MEMORANDUM FOR: Martin J. Virgilio, Director, Project Directorate IV-2

Samuel J. Collins, Director, Division of Reactor Safety

LICENSEE REDEFINITION OF REACTOR COOLANT SYSTEM LEVEL AT WHICH REDUCED INVENTORY OPERATING REQUIREMENTS ARE IMPOSED

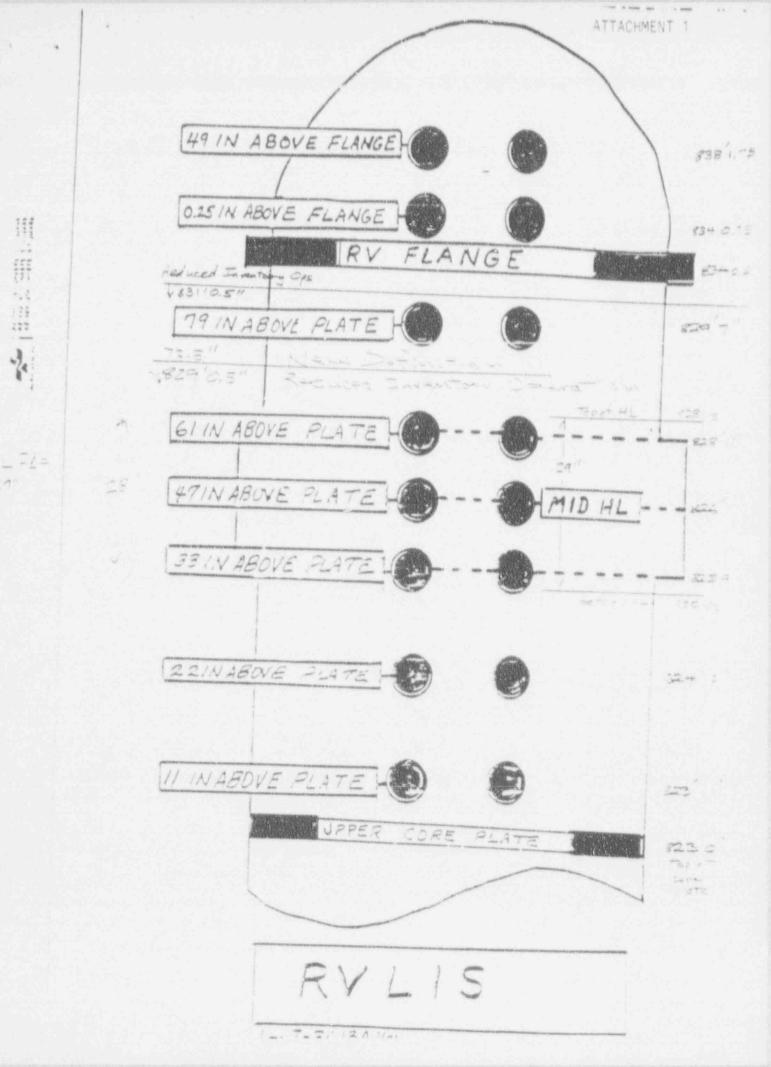
The Attachment I sketch illustrates the physical effect of this change. Attachment 2 is the pertinent pages of NRC Inspection Report 50-423/89-08 for Millstone 3 dealing with a similar redefinition of reduced inventory. Acceptance of this redefinition at Millstone 3 was apparently based on verbal concurrence by someone in NRR. The technical basis appeared to be that residual-heat removal air entrainment would not occur at the lower reactor and the NRC on the subject of revision of the reactor copiant system level for entering reduced inventory conditions. The final NRC letter September 30. 1991) stated that a review of the 10 CFR Part 50.89 evaluation supporting the ower reactor coolant system level for reduced inventory operating restrictions would be considered. This review was completed and documented in MRC inspection Report 50-445/91-61: 30-446/91-61 for Comanche Peak (Attachment -) his assue was documented as Unresolved Item 445/9161-31 pending further review of the technical casis supporting reduction of the reactor coplant system level at which reduced inventory operating restrictions are applied. -ttachment 5 is the licensee's 10 CFR Part 50.59 evaluation supporting its redefinition of reactor coolant system reduced inventory from 3 to 5 feet celow the reactor vessel flance.

appears to be that air entrainment in the residual-heat removal system will not occur at the lower value for reactor coolant system level. Although we agree that avoidance of air entrainment in the residual-heat removal system.

a primary factor for establishing reduced inventory controls, we believe other factors should be considered when redefining the reduced inventory level. The licensee's 10 CFR Part 50.59 safety evaluation indicates that the minimum acceptable level to avoid air entrainment is only 5 inches above actual midloop. We believe the margin of safety associated with the time to boiling and core uncovery upon loss of decay heat removal capability should be considered. This time should be compared with the time required for containment closure to assure adequate margin exists. The results of this evaluation could affect the licensee's conclusions regarding no increase in probability of malfunction of equipment important to safety and no impact on the radiological consequences.

- Does NRR find the redefined reduced inventory level acceptable (5 feet below the flange versus 3 feet)?
- Does NRR agree with the licensee's conclusion that no unreviewed safety question was created by the change?
- Does the licensee's 10 CFR Part 50.59 evaluation provide an adequate basis for the determination of no unreviewed safety question?
- Does the acceptability of changing commitments made in response to generic letters without prior starf approval where the criteria of 10 CFR Part 50.59 are met apply to all generic letter responses?
